SERIAL: HNP-00-065
10CFR50.90

SHEARON HARRIS NUCLEAR POWER PLANT
DOCKET NO. 50-400/LICENSE NO. NPF-63
REQUEST FOR LICENSE AMENDMENT
TECHNICAL SPECIFICATIONS 3/4.4.9.2, 3/4.4.9.4

BASIS FOR CHANGE REQUEST

TECHNICAL SPECIFICATION PAGES

FIGURE B 3/4.4-1

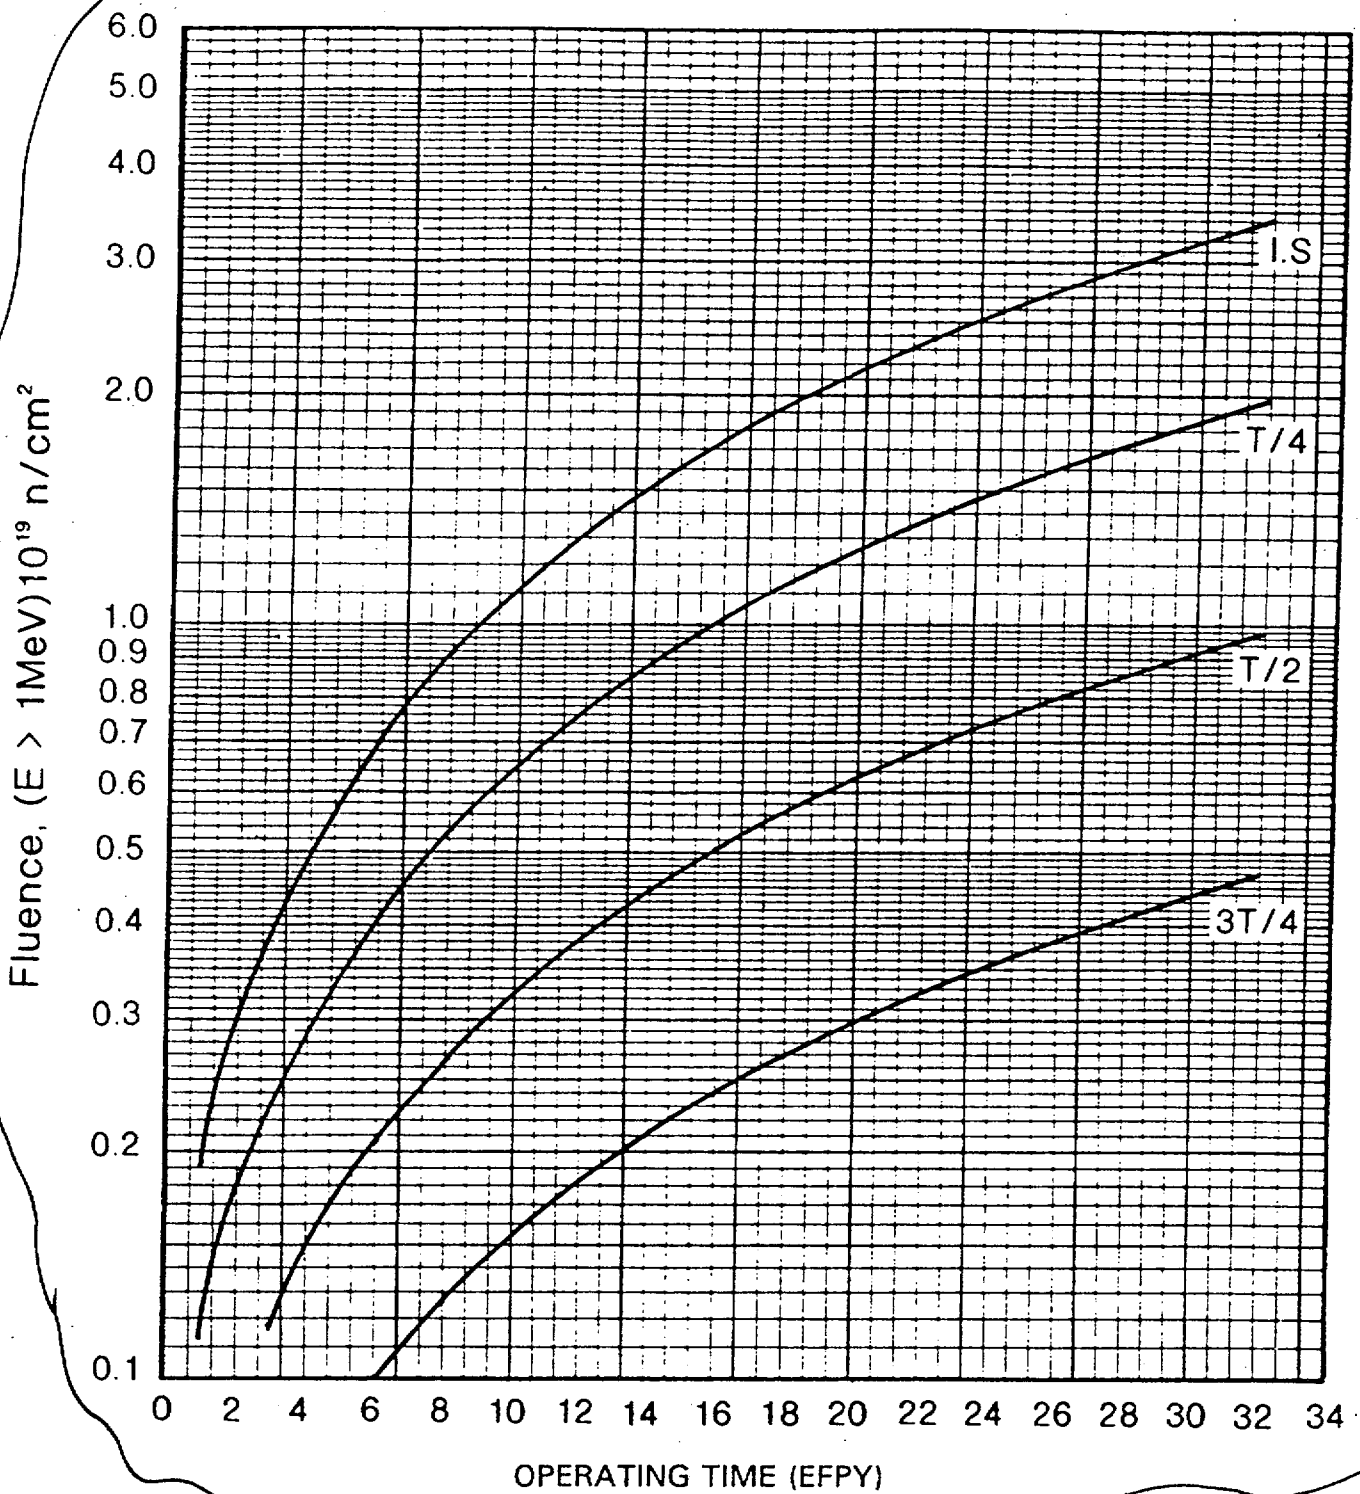
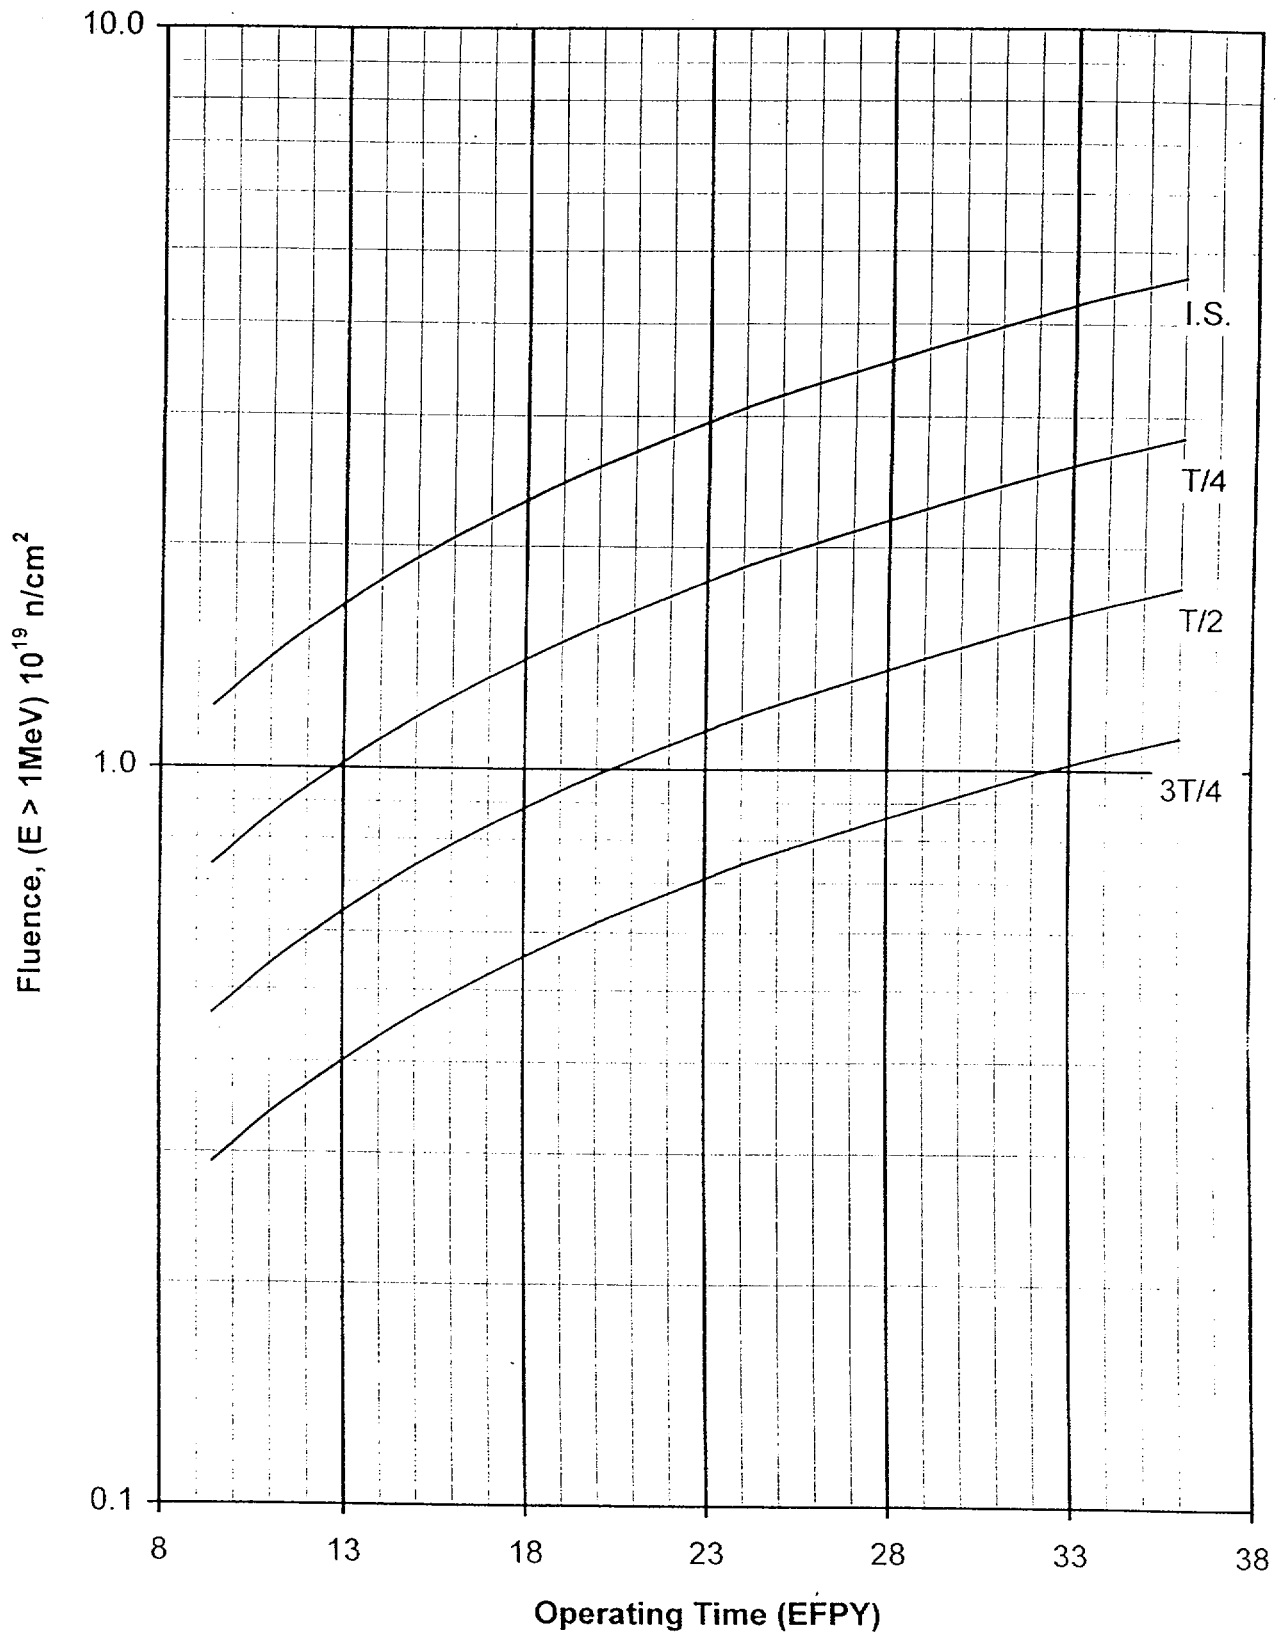
Add Insert
Delete
Delete

Insert

FIGURE B 3/4.4-1
FAST NEUTRON FLUENCE ($E > 1\text{MeV}$) AS A FUNCTION OF FULL POWER SERVICE LIFE
